**REMARKS**

Serial No. 09/695,704  
 Amendment Dated Aug 15, 2003  
 Annotated Sheet Showing Changes

FIGURE 1.2A

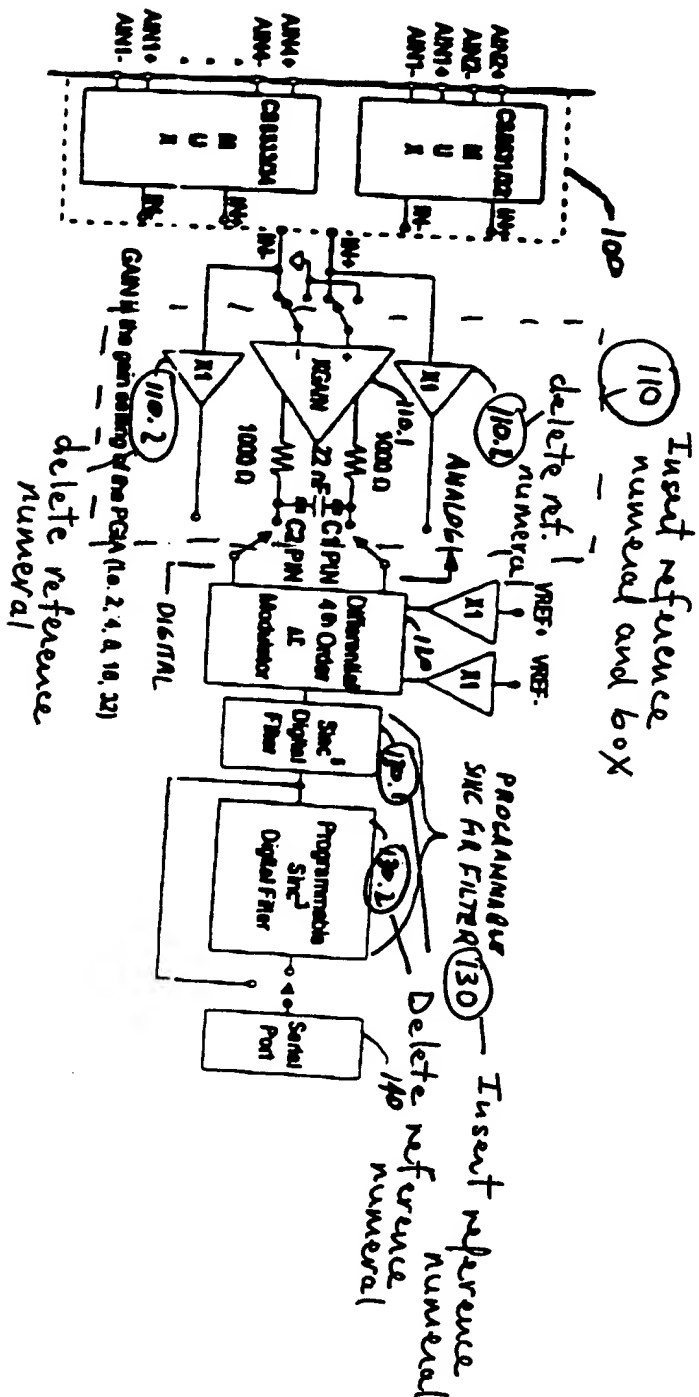
I insert  
ref. numeral

FIG 1.2c  
 (Prior Art)  
 Insert

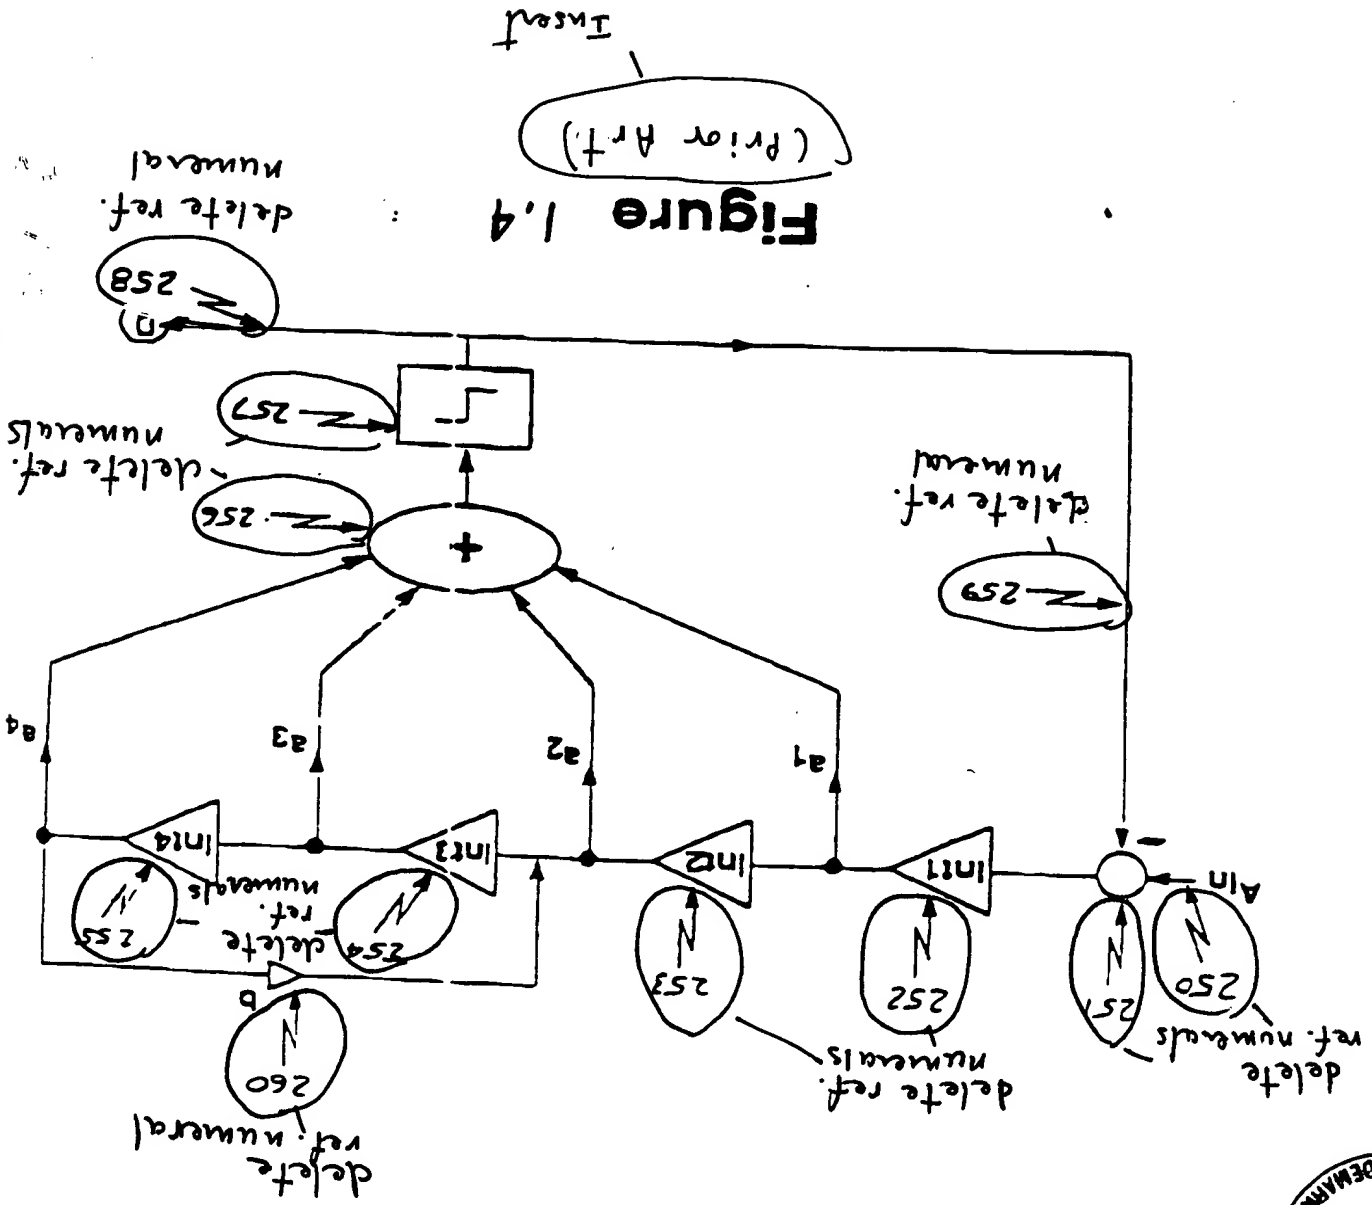
Additionally, Figures 1.2(C) and 1.4 were objected to as failing to include a legend such as "Prior Art." New Figures 1.2(C) and 1.4 have been filed concurrently herewith bearing the legend "Prior Art."

**Figure 1,4**  
(Prior Art.)  
Insert

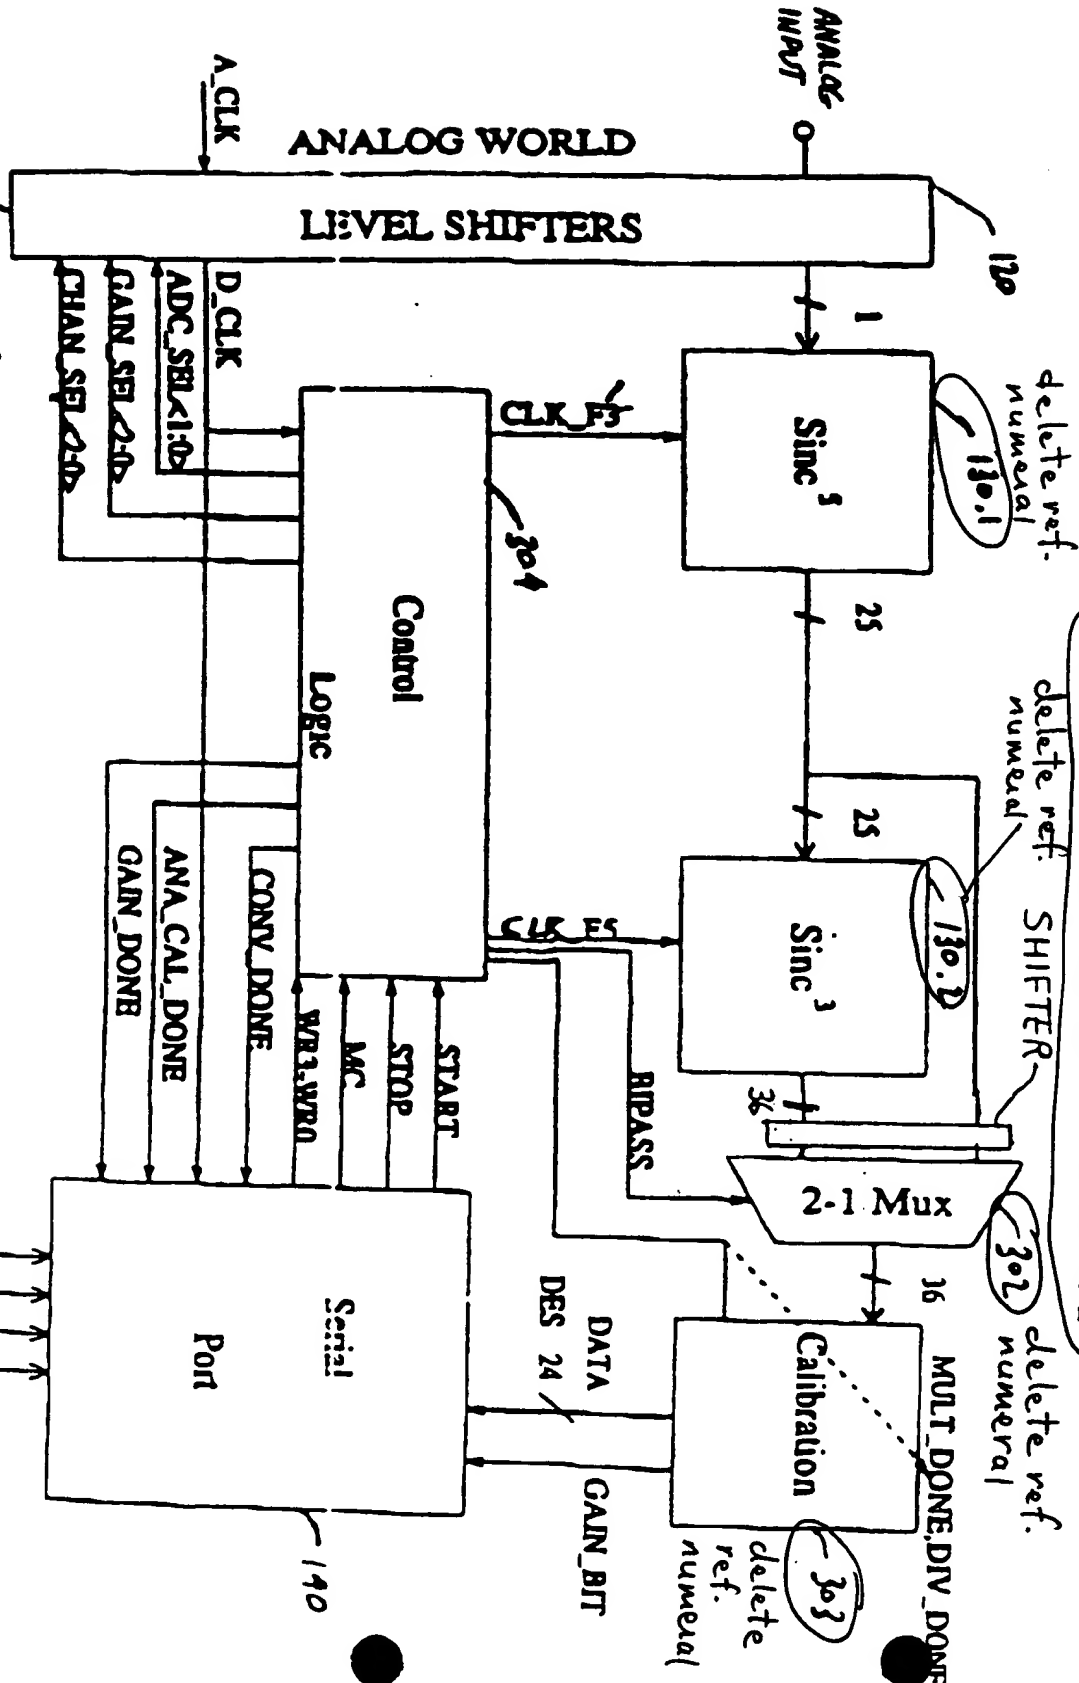
delete title
